**Informations techniques/Technical Matters****Industries Bouchard, Inc.**

DATE July 10 1970Re: 1970 Mini-Sno

TM/70-04

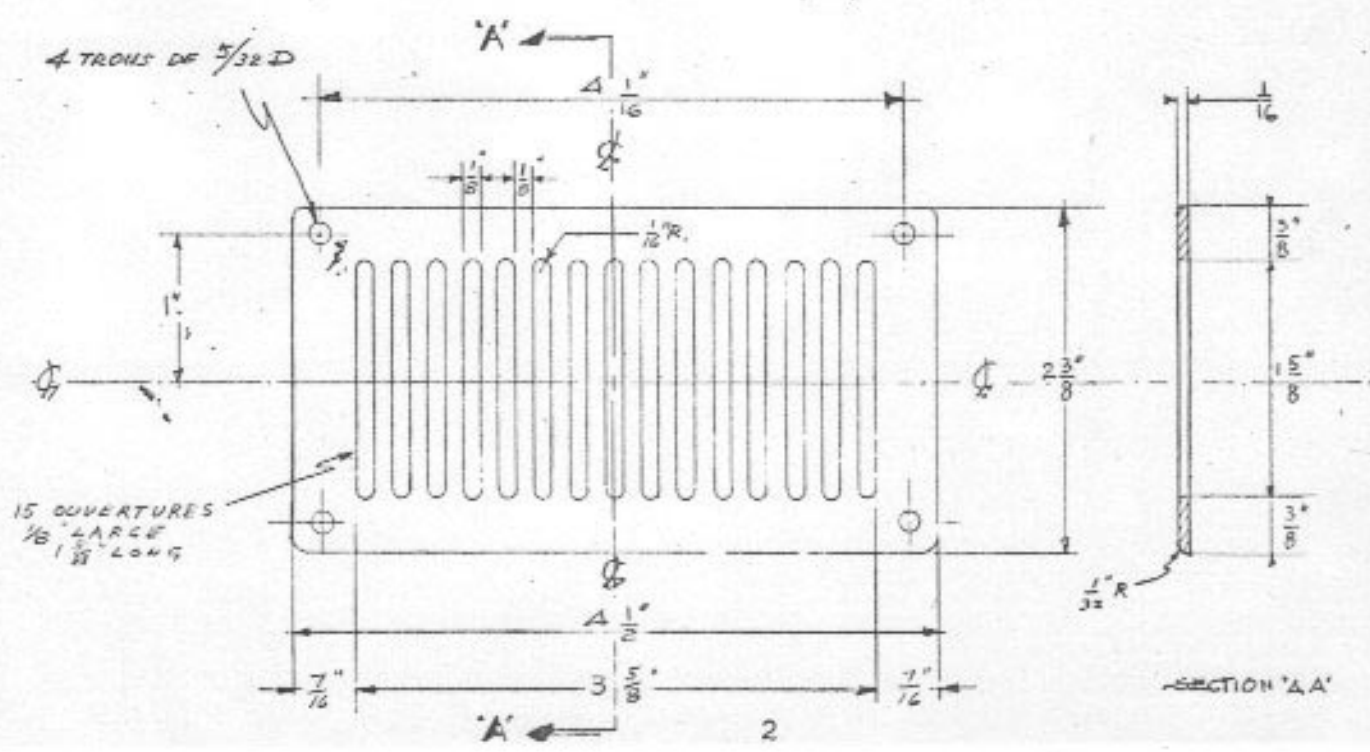
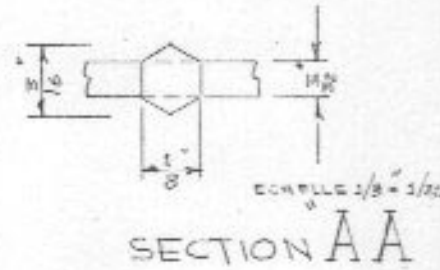
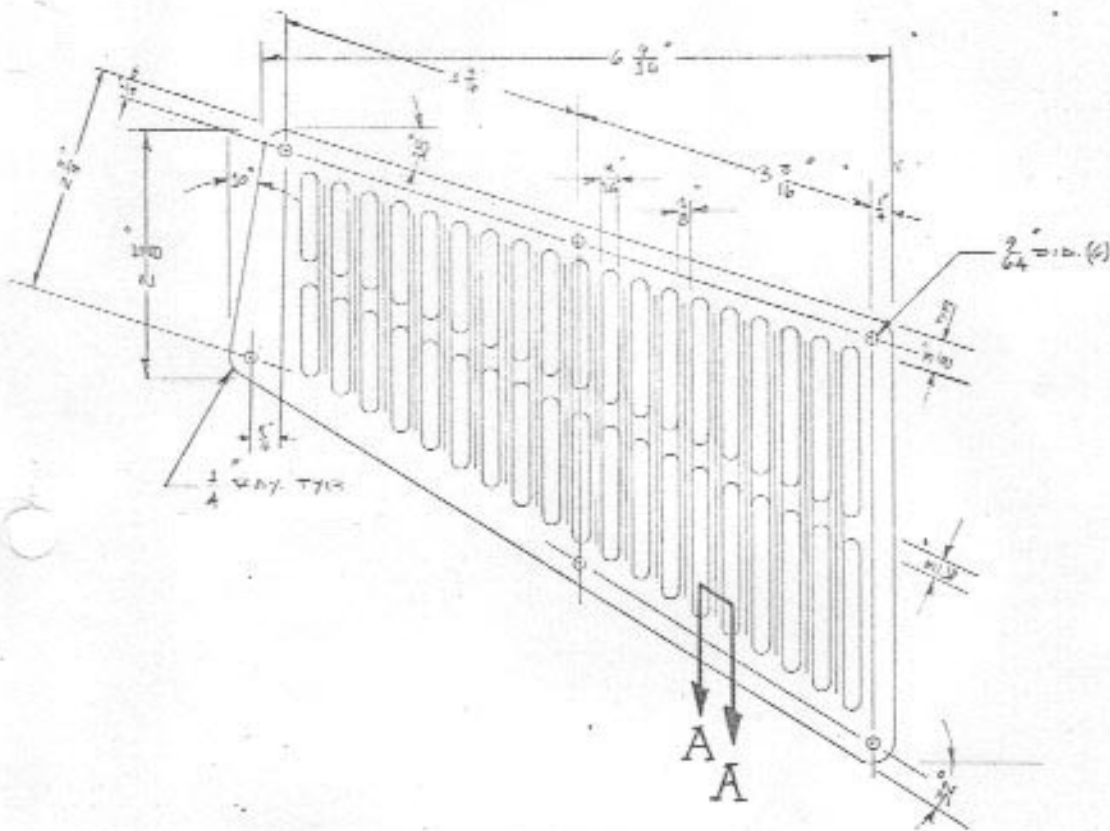
On the 1970 Mini-Sno models, the engine cover seems to produce an overheating condition.

A diagram is included to provide the information concerning the location where the vent grills are to be mounted.

The return line elbow must be installed at a angle of thirty degrees (30°) upwards with the line going over the carburator, coming down under the engine and hooked up to a two way fitting provided for the tank.

In order to increase the flow of air under the cover to keep the carburation at a permitted temperature for proper operation, a kit containing vent grills, return line, elbow fitting as well as a spacer for the carburator is available through regular channels.

The insulator block contained in the kit will provide, when installed between the motor and the carburator, a sufficient control of the heat transferring from the motor to the carburator.

The part kit is available under no: IL-1001
